Cultural Heritage Impact Assessment (CHIS) – Addendum

Robertson Martin Architects (RMA) was retained in May 2020 by Fotenn Planning Consultants to submit an update/ addendum to the *Cultural Heritage Impact Statement* (CHIS), prepared by RMA in May 2018, for the redevelopment of the Medical Arts Building Development (the site), at 180 Metcalfe Street, Ottawa. This addendum is written as part of an Application to the City of Ottawa for changes to the originally conceived and approved design (approved June 2019). It includes an increase in building height resulting in OPA, ZBA and Site Plan revision applications for 180 Metcalfe Street. This addendum will

Figure 1: All elevations of 2020 proposed design (images courtesy of Roderick Lahey Architect).

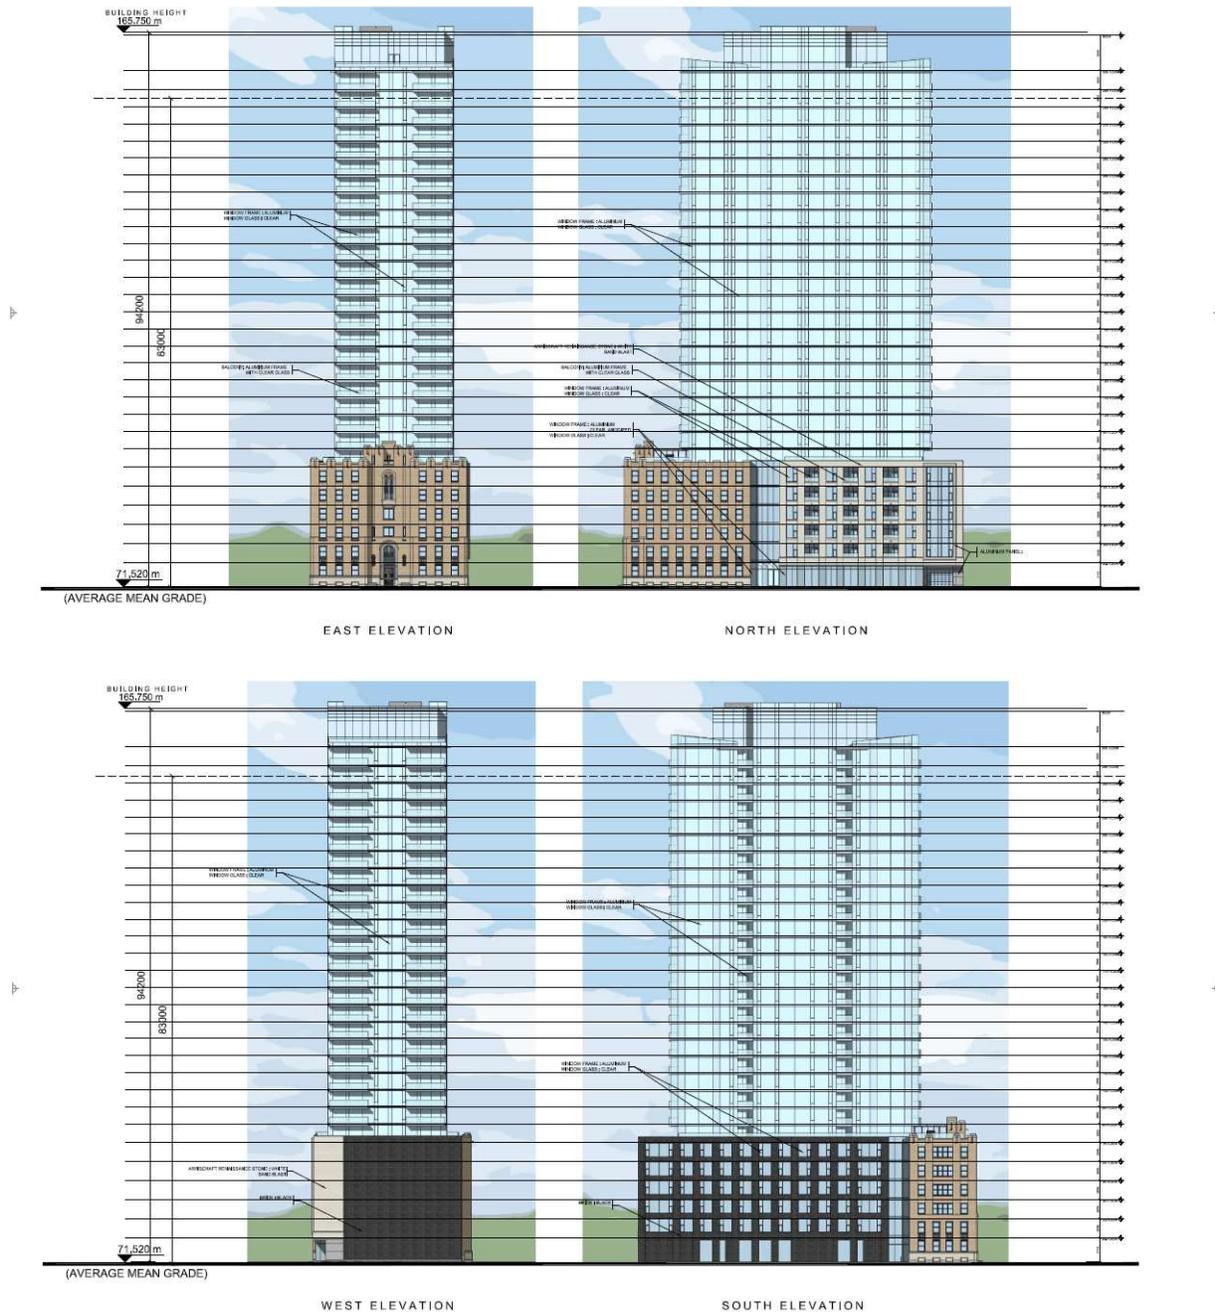
Penthouse - The revised penthouse design was set-back from lower levels of the tower on the east and west facades, but not the north and south. The colour and uniformity of the material between the tower and the penthouse reduces the visual heaviness of this element. Thus, the lack of set-back on the north and south elevations poses no impact on the heritage site.

Podium - The approved design maintains the six-storey podium which speaks to the original building height. The design also maintains the glazed vertical “gasket” on the north elevation to physically and visually separate the new and old components of the façades. The façade strategy presented in the approved design shows efforts to draw inspiration from the heritage building with continuation of horizontal datum lines and use of strong vertical piers between windows. The design team is encouraged to create a more *intentional dialogue*, focusing on the proportions and rhythm of the fenestration of the heritage building, such as the height of horizontal datum lines and the width and rhythm of window spacing. Particularly on the south façade, the placement and rhythm of the windows should be refined with more intentional design that speaks to both the historic façade and the tower above.

The original façade strategy differentiated the bottom two storeys on the north and south façades from the upper podium levels, speaking to the double-height street presence of the heritage building. The 2019 design distinguishes only a single storey street presence on the north and eliminates the distinction on the south elevation. Although the double-height street presence speaks truer to the heritage design, the proposed single height strategy of the north façade is acceptable with minimal impact to the understanding of the heritage site. This design change is seen as compatible as the massing aligns the change from glazing to stone with the metal frieze element on the heritage façade. Further discussion can be seen above, under *Material Finishes and Colour*.

In addition, the fenestration at the west corner of the north elevation differs from the rest of the façade; however, the physical distance of this element minimizes the visual impact and the appreciation or understanding of the heritage building.

Podium- The use of lighter brick on the north façade ties nicely with the limestone foundation of the heritage building and creates a more subtle distinction between the historic and new components. However, the design team is encouraged to consider use of a contrasting element, such as the black brick veneer, between the first and second floor levels, to highlight the visual continuation of the datum line created by the heritage metal friezes onto the new façade. This feature will also work to tie together the use of the contrasting brick colours in the new design.

The recommended integration of a black “ribbon” element on the north façade should continue around the north-west corner on the west façade. On the west façade, minimal other changes are proposed to finishes from the original, and as such do not affect the previous impact assessment.

On the south façade, the use of black brick on all podium levels eliminates the distinction between the street level and the upper storeys as was evident in the original design. The design team should consider the use of the lighter brick at the ground floor to create a visual connection between the heritage building and the new façade. See *Fenestration and Massing* section above for further discussion on the street presence of the south elevation.

- The execution of the new construction should prioritize quality of materials and craft to compliment the quality of the heritage building;
- Consider use of black brick veneer between the first and second floor levels to highlight the continuation of the datum line created by the metal friezes on the heritage façade and to tie together the use of contrasting brick colours on all new podium elevations; and,
- The design team is encouraged to create a more intentional dialogue, between the podium and retained heritage facades, focusing on the proportions and rhythm of the fenestration of the heritage building, particularly on the south elevation.

Figure 3: Parliament Hill protected view projection (image courtesy of Roderick Lahey Architect).

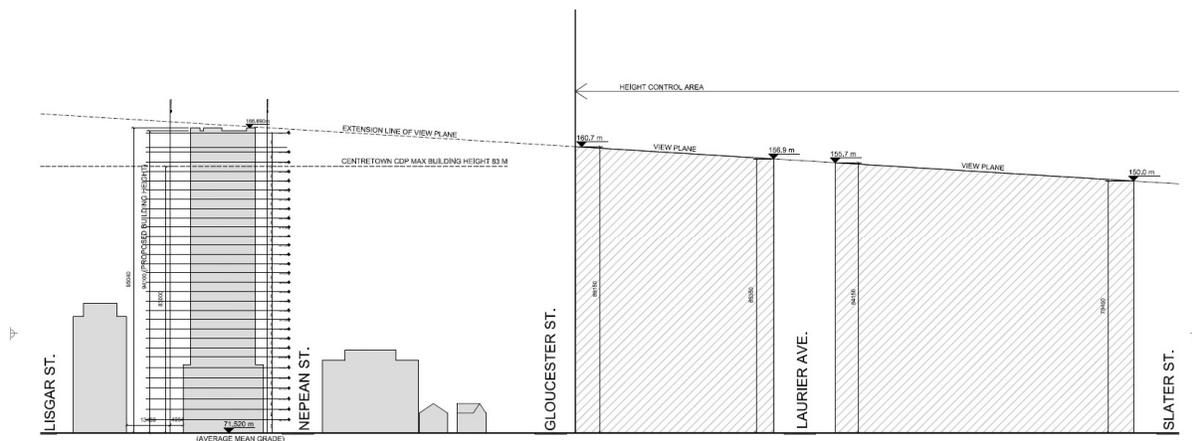
The proposed increase in overall building height to 30 storeys or 94.2m exceeds the maximum building height for the site as identified in the Centretown Community Design Plan. This increase is primarily a planning concern and does not impact the heritage character defining features of the site. More importantly, the overall building height falls within the projected angular height control plane of the protected view of Parliament Hill. An earlier iteration of the design proposed an additional four storeys with moderate impact on the line of sight of the Parliament Buildings. However, this revised design reflects the recommendations of RMA and Fotenn to reduce the height of the building and eliminate the impact on the protected view.
